# MEMORANDUM

**Project:** SRDC Fishing Dock Rehabilitation

**Subject:** Addendum 2 Memo

**GENERAL STRUCTURAL NOTES 1**

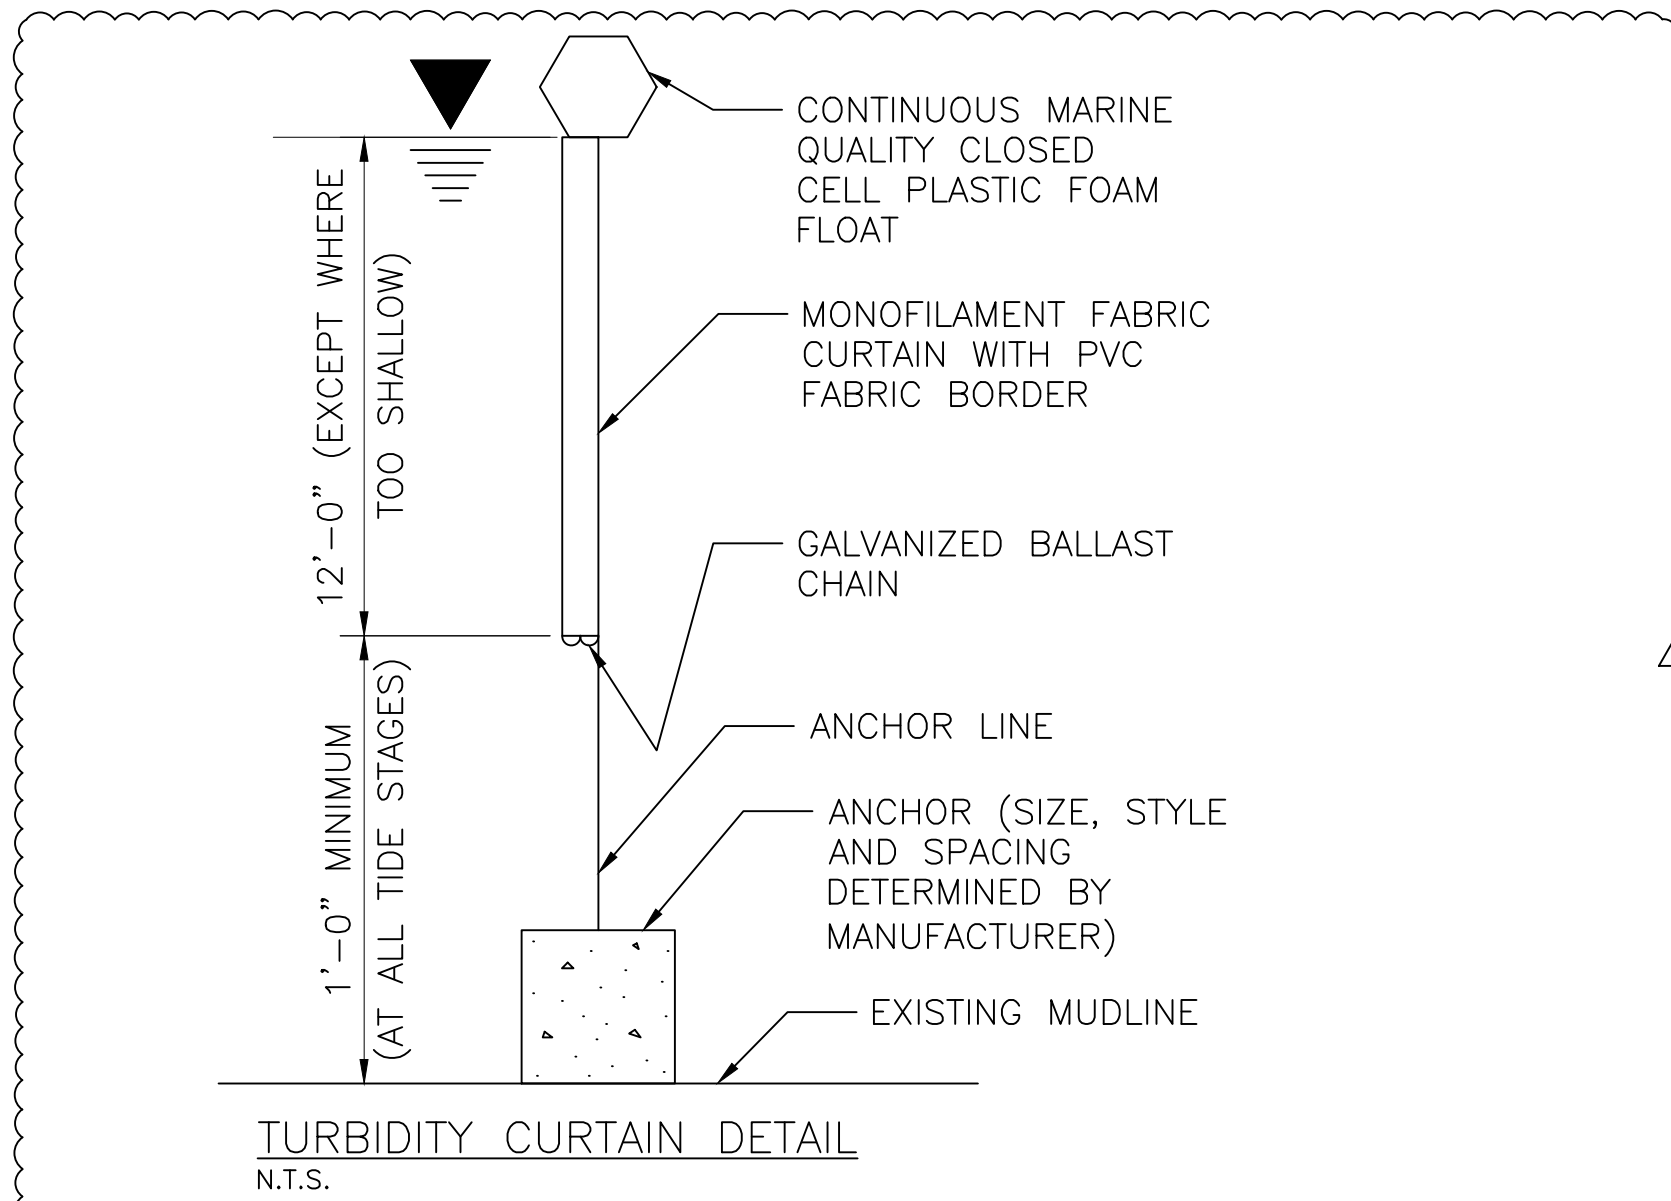
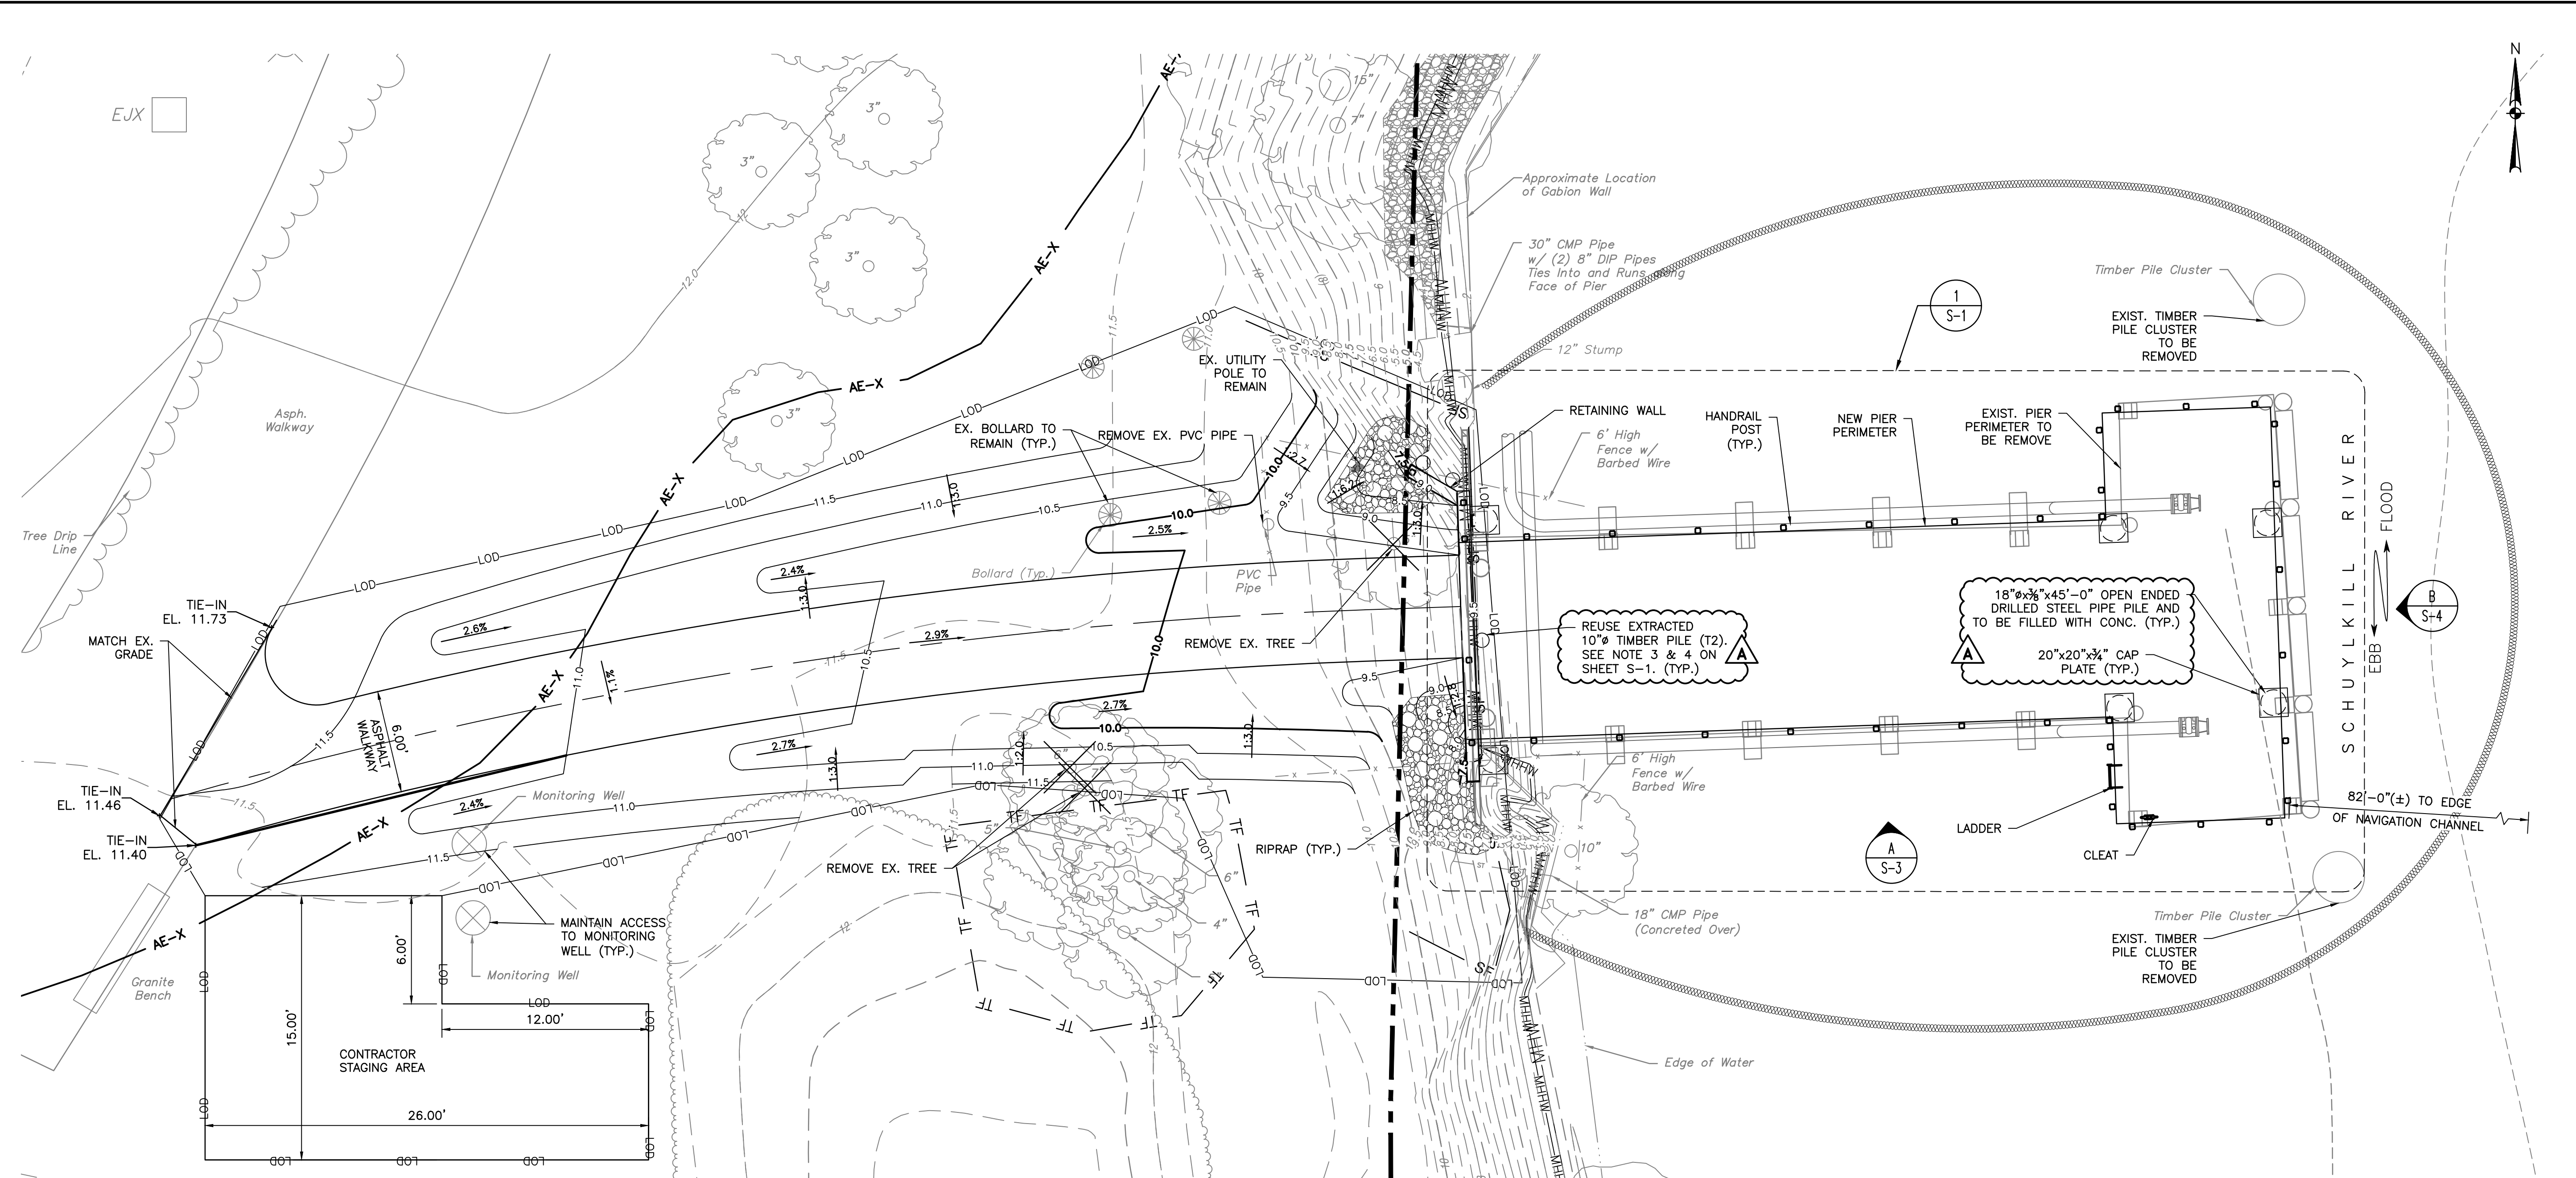
This bid addendum includes: Revision A to DWGs GN-02 and CV-01. These drawings have been revised to correct typos and to include the details for the turbidity curtain. In general, revisions are clouded, or bolded and italicized.

- A FLOATING TURBIDITY CURTAIN SHALL BE PLACED TO ENCOMPASS AREAS WHERE SEDIMENT MAY BE GENERATED AS A RESULT OF PROJECT WORK. A TURBIDITY CURTAIN MUST BE IN PLACE FOR ACTIVITIES THAT MAY GENERATE TURBIDITY, INCLUDING: PILE INSTALLATION OR EXTRACTION, PLACING CONCRETE UNDERWATER, DREDGING OR UNDERWATER DEBRIS REMOVAL, AND DEMOLITION.

- THE CURTAIN HEIGHT SHALL NOT EXCEED 12 FT, AND SHALL BE SHORT ENOUGH TO MAINTAIN A 1 FT GAP BETWEEN ITS BOTTOM AND THE MUDLINE AT MEAN LOW WATER.
- UNLESS NOTED OTHERWISE, THE TURBIDITY CURTAIN SHALL BE A TRITON TYPE III PERMEABLE SILT AND TURBIDITY BARRIER, OR APPROVED EQUIVALENT. WHERE NO TIDAL FLUCTUATION OR CURRENT EXISTS, A TYPE II BARRIER MAY BE USED. SUBMIT PROPOSED BARRIER SPECIFICATIONS, ALONG WITH THE MANUFACTURER'S RECOMMENDED CONDITIONS FOR USE.
